ADDENDUM NUMBER ONE (1)

RE: BID NO. 2013-29 – UPGRADE OF LIFT STATION No. 40

OWNER: CITY OF EDINBURG

SHEET:
 E - 4
 of 5

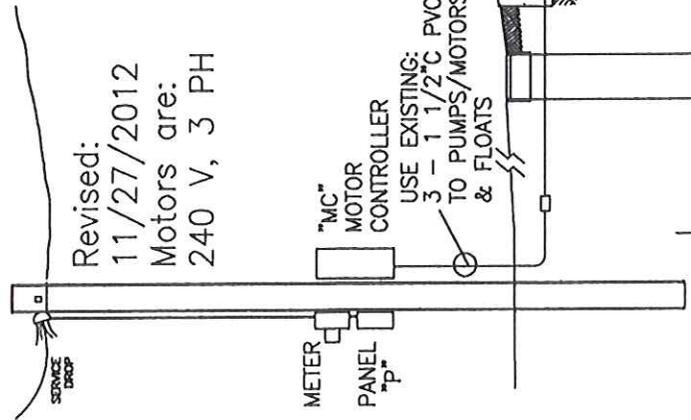
COLEMAN CABLE CO. DOES NOT HAVE A CABLE FOR
 USE IN "SEWER" SYSTEMS. THE "PVC" JACKET CABLE
 WAS THE ONLY THING THEY COULD SUGGEST.

"MC"
 MOTOR
 CONTROLLER
 USE EXISTING:
 3 - 1 1/2" PVC
 TO PUMPS/MOTORS
 & FLOATS

SHEET:
E - 5
of 5

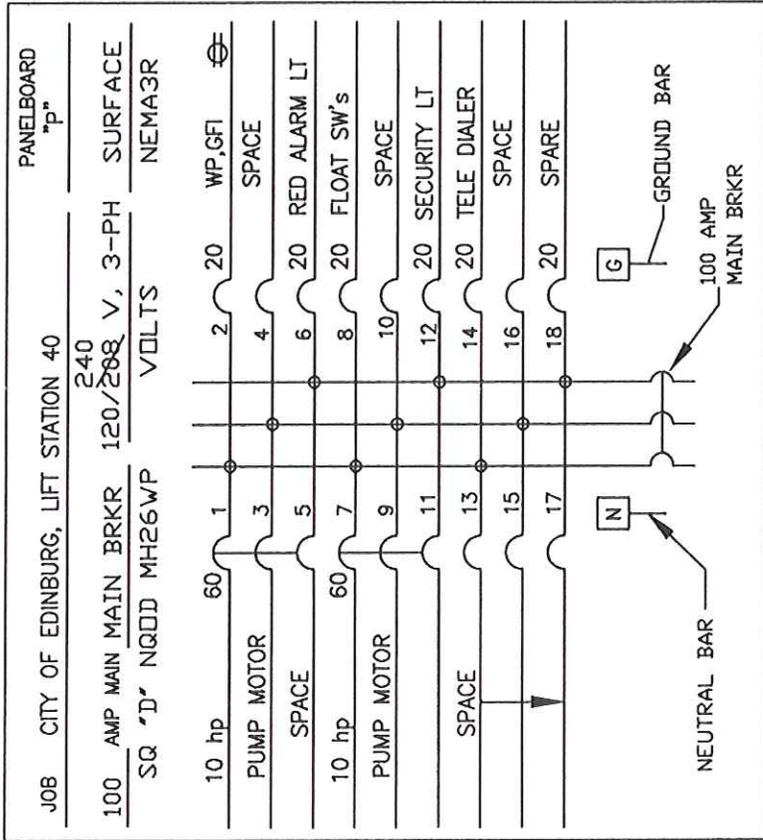
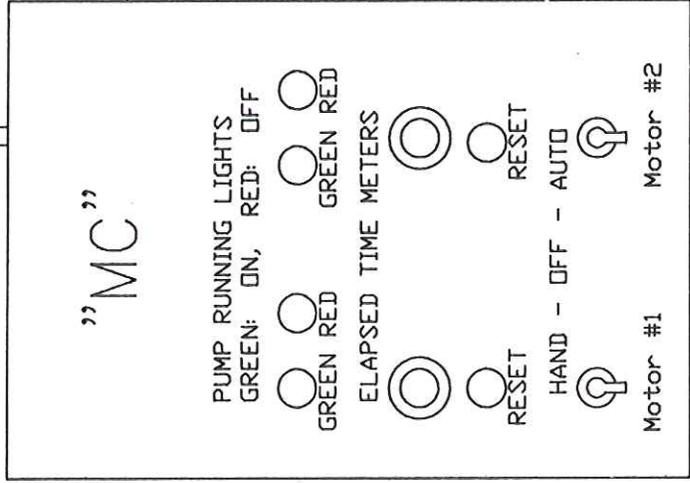
REVISED: THE MOTOR/PUMPS COMBOS ARE 240 V, 3 PH 11/27/2012
